E8364C-02

S E R V I C E N O T E

E8364C PNA Microwave Network Analyzers

A new touchscreen display inverter shield is available to improve PNA noise floor performance.

Figure 3

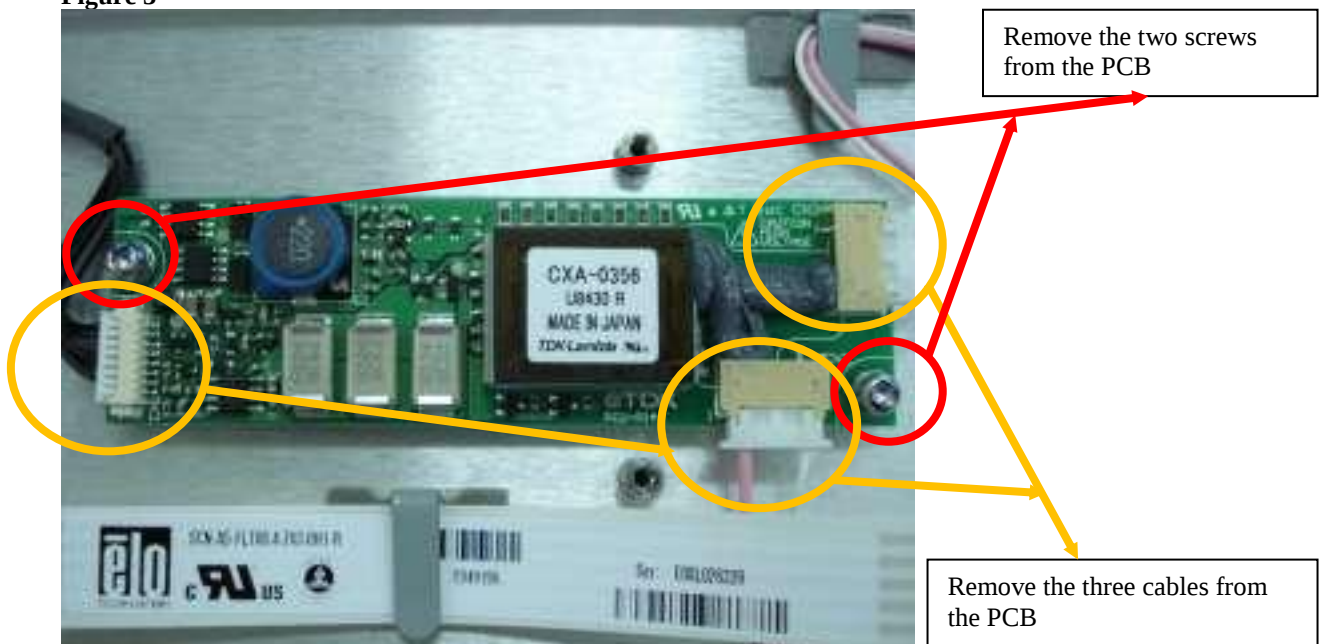
10. Remove the two screws from the PCB shown in Figure 3, using a T-10 wrench.
Disconnect the three cables connected to the PCB.
